Field Service Bulletin Trucks

Height Control Arm Position, Adjustment CHU, CXU

FSB 728-003, Height Control Arm Position, Adjustment

(April 2017)

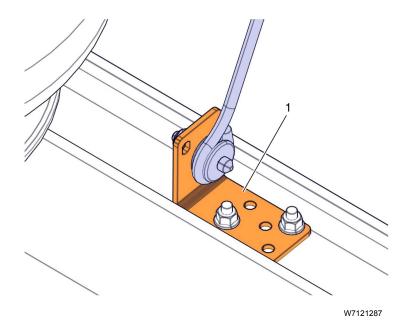
Some MACK CXU612/CHU612 trucks built from October 4, 2010 to February 6, 2017 with single rear axle Hendrickson air suspension (RAD-A2H) and short tapered frame rail (RFL830, RF-TAP28/RF-TA28T) could have the level arm rise above the frame rail when suspension is lowered completely. To eliminate this problem the arm should be adjusted (rotated 180°) forward and the leveling rod should be moved to the front of the air spring support crossmember and reinstalled with bracket (part number 20839697) and existing hardware.

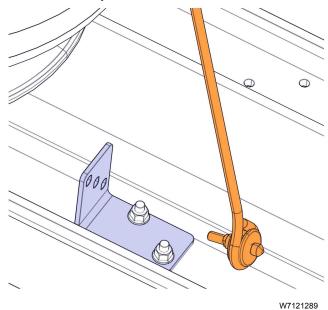
3 Position the level control rod away from the control rod bracket as shown.

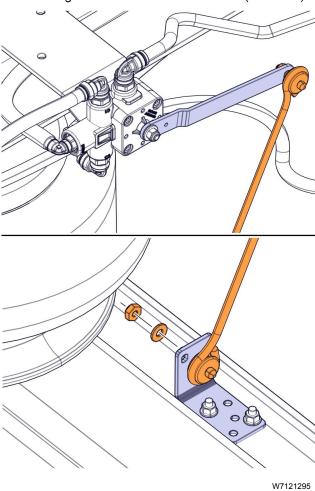
8 With the leveling rod still attached, rotate the control arm 180 degrees. See the figure below for reference.

9 Using the stored fastener, connect the level control rod to the air spring support crossmember bracket as shown in the figure below.

Note: Ensure the level control rod is installed in the middle hole of the air spring support crossmember bracket.
